**PROPOSED UPLAND LANDFILL**

**HYDROGEOLOGICAL REVIEW**

**GW SOLUTIONS**

Victoria, October 6, 2017

25  
FIGURE 2.9

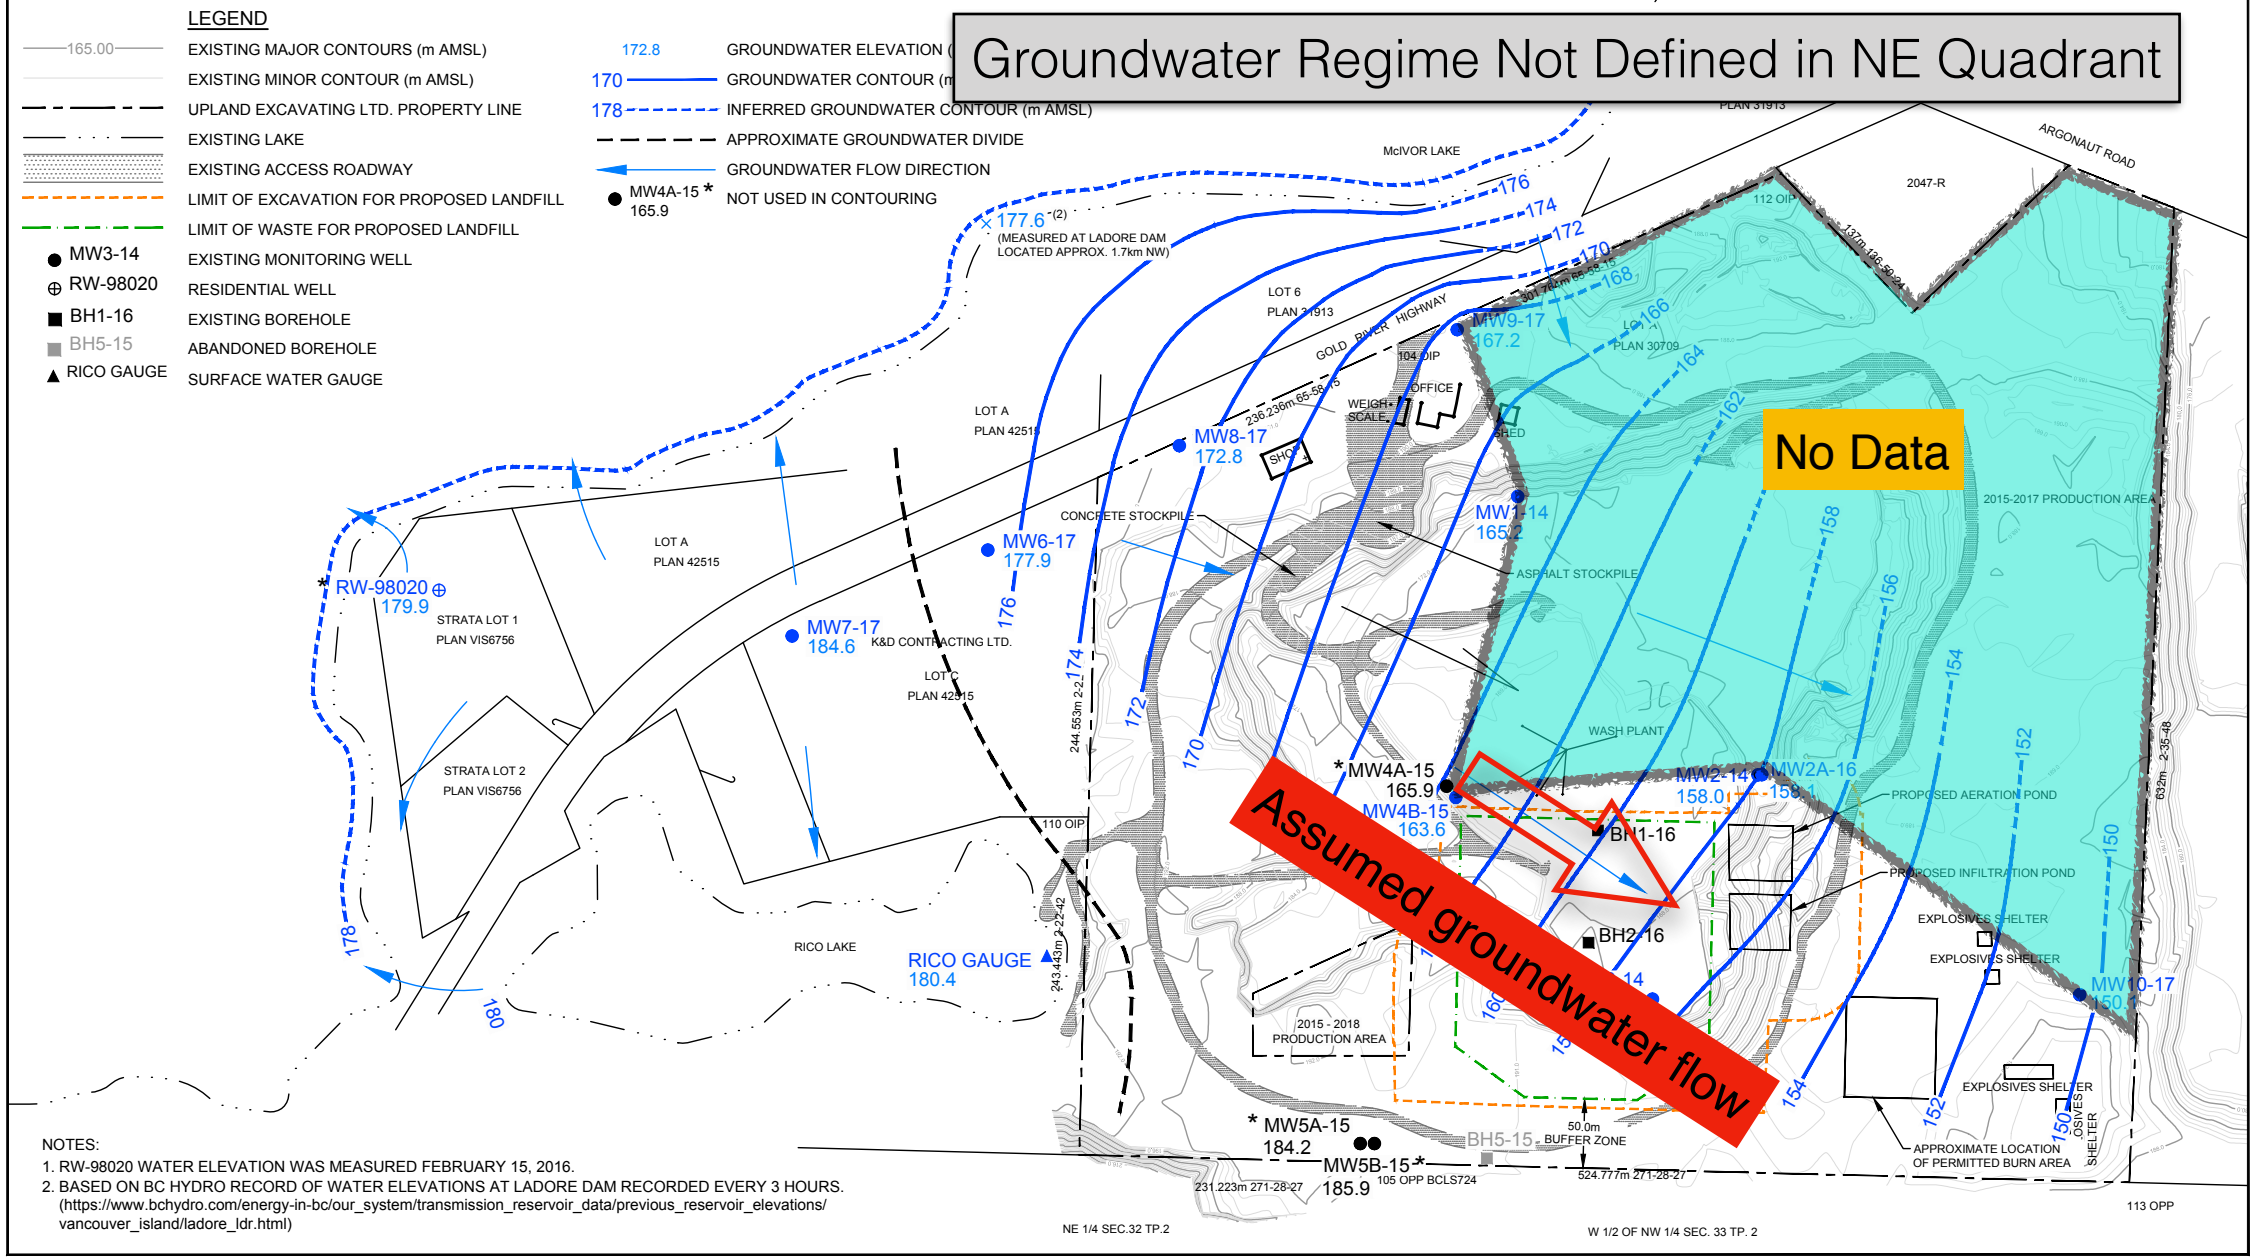
# Groundwater Regime Not Defined in NE Quadrant
